## COUNCIL ASSESSMENT REPORT

<b>Panel Reference</b>	2017SCL024
<b>DA Number</b>	DA/132/2017
<b>LGA</b>	Randwick City Council
<b>Proposed Development</b>	Demolition of all existing structures in the south western corner of the site and construction of two buildings (E & F) containing a total of 79 independent Living Units (ILU's) purposes of Senior housing at the south western corner of the Montefiore Seniors Housing site
<b>Street Address</b>	30-36 Dangar Street, Randwick NSW 2031
<b>Applicant/Owner</b>	Equity Development Management/ Sir Joseph Montefiore Jewish Home
<b>Date of DA lodgement</b>	10 March 2017
<b>Number of Submissions</b>	Three (3)
<b>Recommendation</b>	Approval
<b>Regional Development Criteria (Schedule 4A of the EP&amp;A Act)</b>	6 Private infrastructure and community facilities over \$5 million Development that has a capital investment value of more than \$5 million for any of the following purposes: (a) air transport facilities, electricity generating works, port facilities, rail infrastructure facilities, road infrastructure facilities, sewerage systems, telecommunications facilities, waste or resource management facilities, water supply systems, or wharf or bo

Figure 8: operation of glazing within one bedroom apartments allowing for flexible arrangement of open space and internal living space for single bedroom apartments.

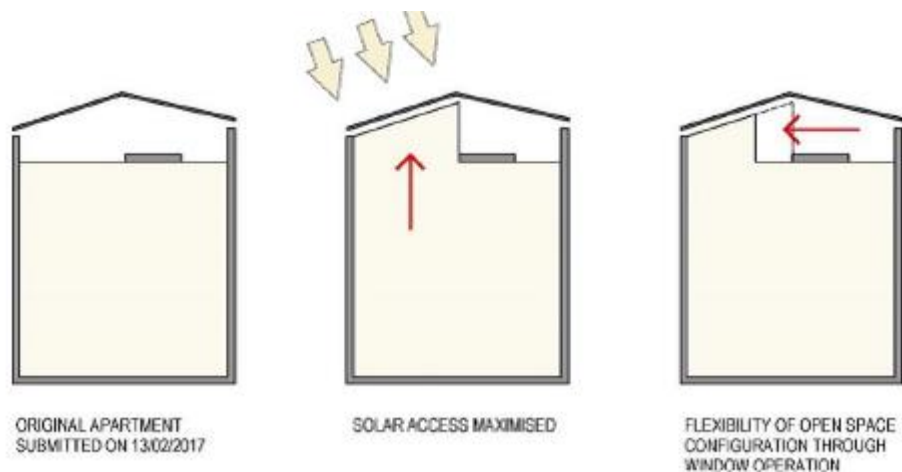
*Solar access to the balconies appears to be restricted by the angle of the particularly elevation design, with the protruding living spaces placing the glazing line at edge of the building, both limiting solar access to the bedrooms and placing a greater heat-load on the glazing. The panel questions the advantage of the chamfered glazing line.*

- Amendment to the projections along the façade of one bedroom units will result in shortfall of balcony area down to 7sqm which is 1sqm short of the 8sqm required under the Apartment Design Guide (ADG) affecting five units in total (F11, F21, E21, F31 & E31). The shortfall is minor and as indicated above the amendments provide for greater consistency in architectural form across the eastern elevation of both buildings and when the living room is open it allows for a large area of open space as shown in figure 8 below.
